BY-LAW NO. 2024 - 12

Rezoning Lot 10 south of Bleams Rd

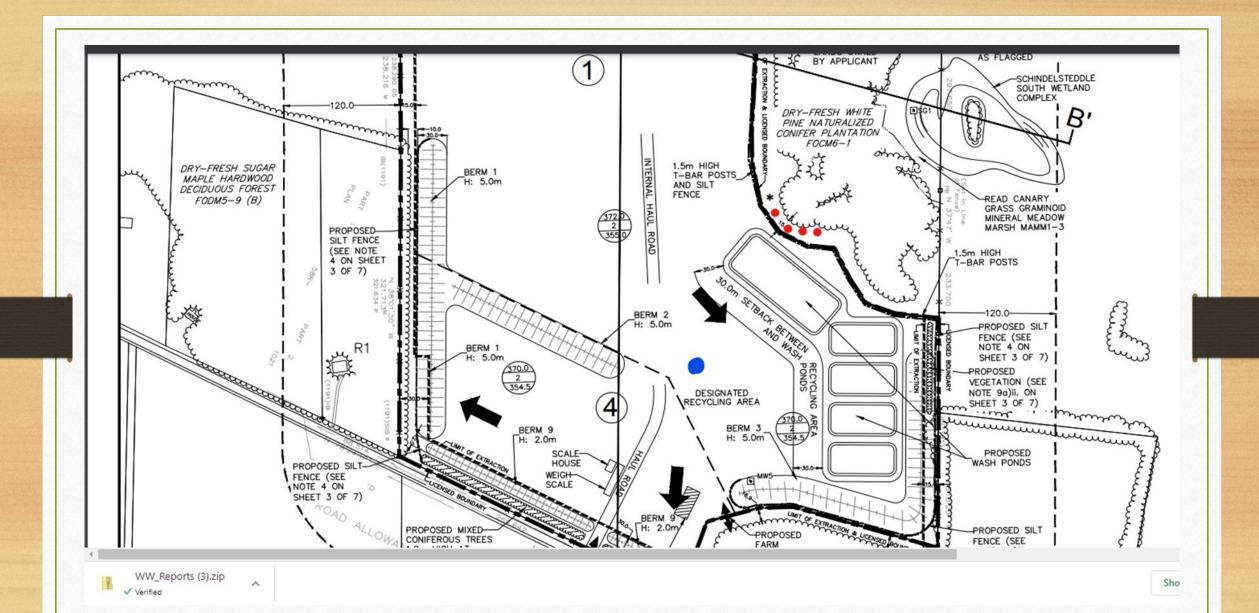
The purpose of this wellhead set up was to dilute liquid manure from the lagoon (large pipe coming from opposite the lane that acted as a dam) with fresh water and distribute via an underground system.

There was once an insulated shed protecting the well / pump station from frost, as seen in older areal pictures.

It was never investigated if this set up was fit with a backflow valve or if contaminated water could enter the aquafer below whenever the well was shut off.

Was the water sampled?

The operational plans do not show the location of this well. The Blue Dot added to this plan represents the approximate location of the irrigation well.

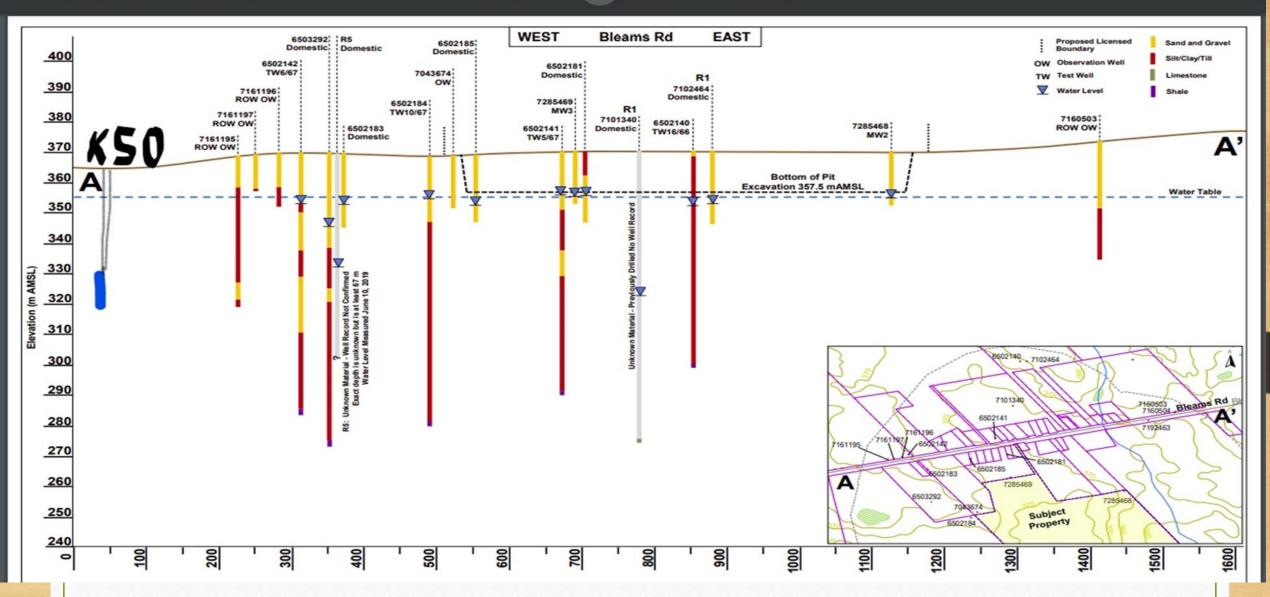
Conveniently located next to the first wash pond but also next to the designated concrete and asphalt recycling area.

Why it matters: No need to apply for a permit to take water?
Would asphalt storage and recycling be permitted on top of a wellhead?

Runoff from Asphalt storage as seen at a pit south of and bordering Witmer Road

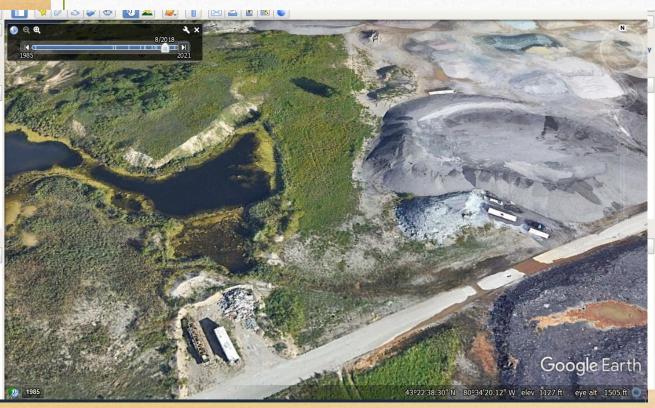
The brown patches in the picture are most likely hydro-carbon run off crossing the road even on a summer's day.

We are promised that a 30-meter distance between the asphalt recycling area and wash ponds sitting in the water table will keep us safe.

In reality, outcomes like these could be expected in the Hallman pit too.

1894 Witmer Rd, CON South of Bleams Rd, PT LOT 10 Township of Wilmot, Regional Municipality of Waterloo Figure 1: Well Locations

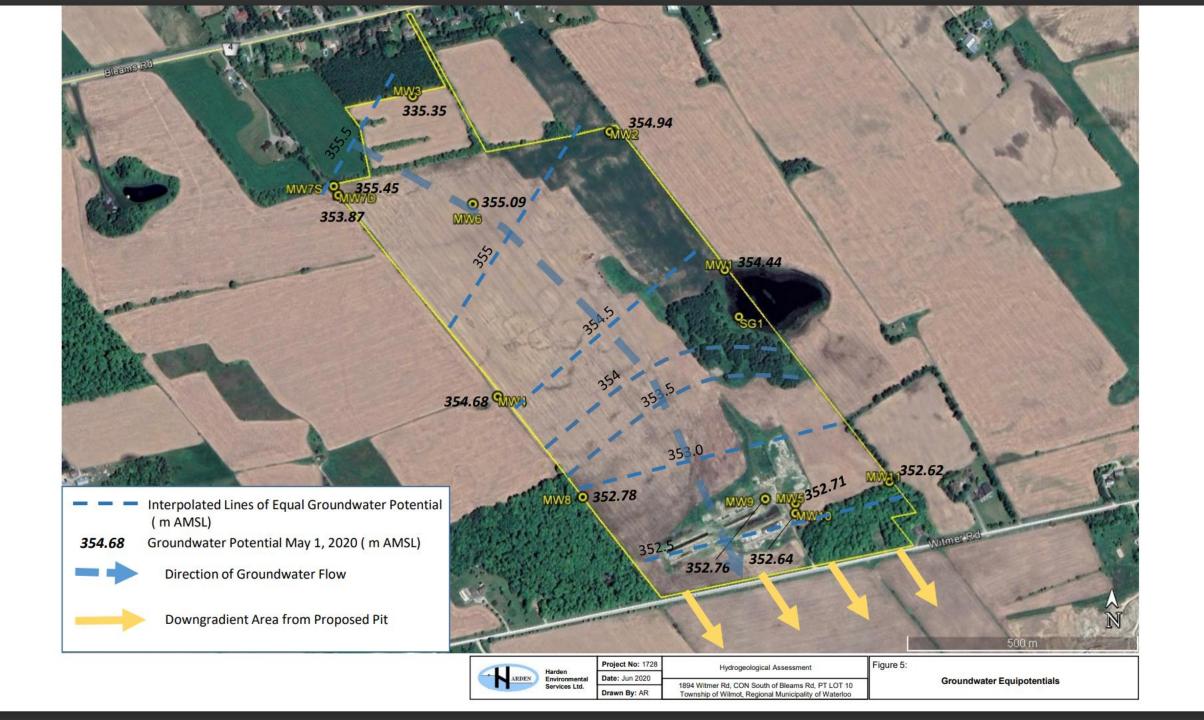
The only Map showing on site wells: A1 and A2

Appendix H; Spill Management plan shows 2 wells, A1 and A2 without further description. These wells are not shown in any other document nor are they described why they are important to spill plan. As a source of water in an emergency or in need of protection in case of a spill?

The location of A2 is the irrigation well and pump station, and therefore whoever prepared the document was aware of it but deliberately ignored the data from this well record when demonstrating a thick aquitard under the site.

The May 2000 file shows Wells A1 and A2

The same file dated June 2000 doesn't show these wells.
